RURAL ELECTRIFICATION CORPORATION LIMITED
IT Division
CORPORATE OFFICE

TENDER NO: REC/IT/93(S)/05/-ERP/SERVER/1 DATED 19th JANUARY, 2008

PRE-BID CLARIFICATION/MODIFICATION

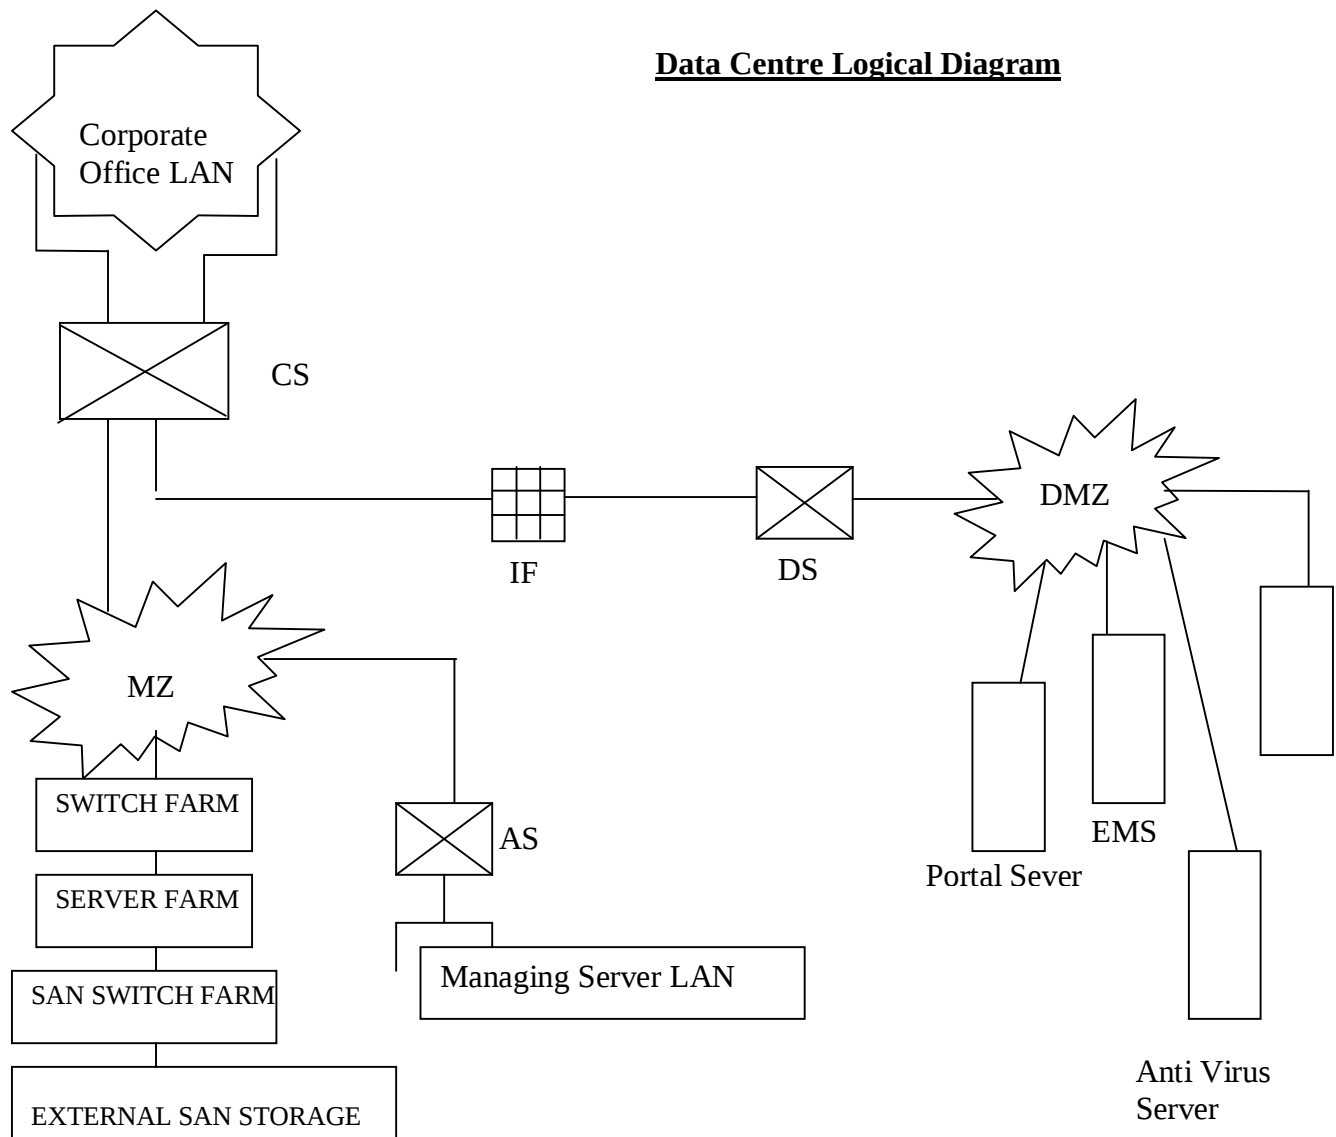
31	Serial 20 - LTO Tape library – number of drives Page - 122	4 extendable to 6 with multi streaming , multiplexing and for restore to optimize the drives scalable up to 18/12 Specification scalability is not clear. Please specify scalability is 6,12 or 18	The complete revised Tape Library specification is given in enclosed annexure with this corrigendum.
32	Serial 20 - LTO Tape library – number of tape cartridges Page - 122	Minimum 30/15 scalable up to 80/40. Slots requirement is not clear from this. Please clarify	The complete revised Tape Library specification is given in enclosed annexure with this corrigendum.
33	Logical diagram Page - 95	What does SA mean in the logical diagram	Modified diagram is enclosed in annexure with this corrigendum.
34	Logical diagram Page - 95	As the database server has to be in HA mode , both the server should be connected to SAN switch and in turn SAN box should be connected to	Modified diagram is enclosed in annexure with this corrigendum.
